# NEWMAR CORPORATION WARRANTY DEPARTMENT

## RECALL SERVICE BULLETIN

DATE ISSUED	MODEL YEAR(S) AFFECTED	RSB #
12/02/2016	2016, 2017	468

## How to Replace Motor on Single Tube Wardrobe Slideout

### Loosening the Shaft Components

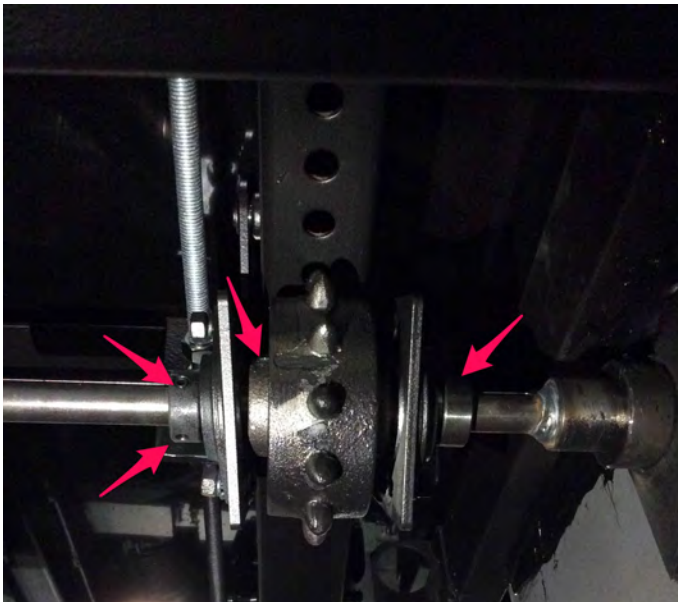
3. Loosen the set screws located at the cog wheel.
4. Loosen the set screws located at both of the bearing retainers.

## Preparing for the New Motor

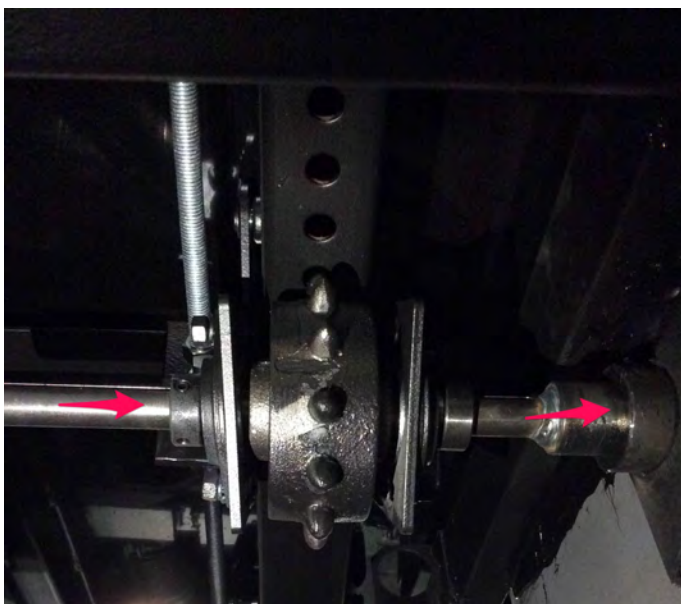
5. Slide the shaft over to allow the new motor to be mounted. If the shaft cannot be moved over, loosen the rubber around it.

6. Slide the shaft over, then place new rubber around the shaft.

7. Slide the trantorque bushing onto the shaft of the new motor.

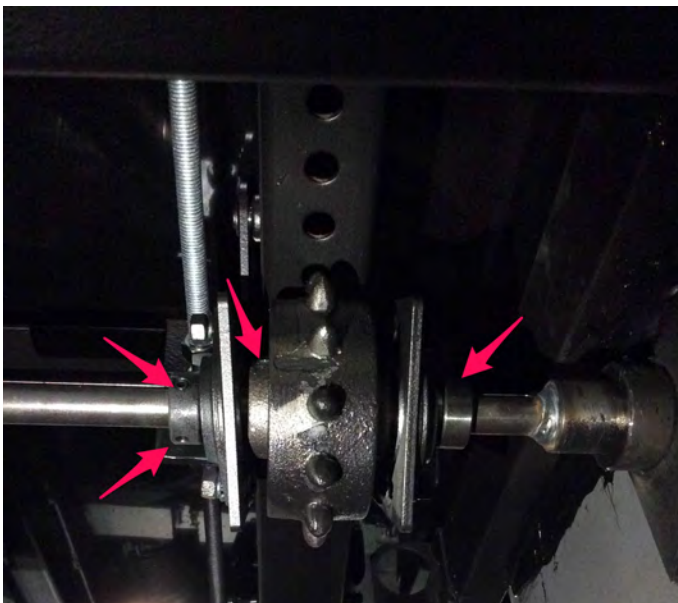
11. Snug up the two motor mounting bolts.
12. Drill a 3/8" hole through the remaining motor mount bolt holes into the mounting plate.
13. Install the two remaining bolts, nuts, washers. Then tighten them.
14. Torque all four mounting bolts to 33 ft. lb., and torque the transtorque bushing to 175 ft. lb.
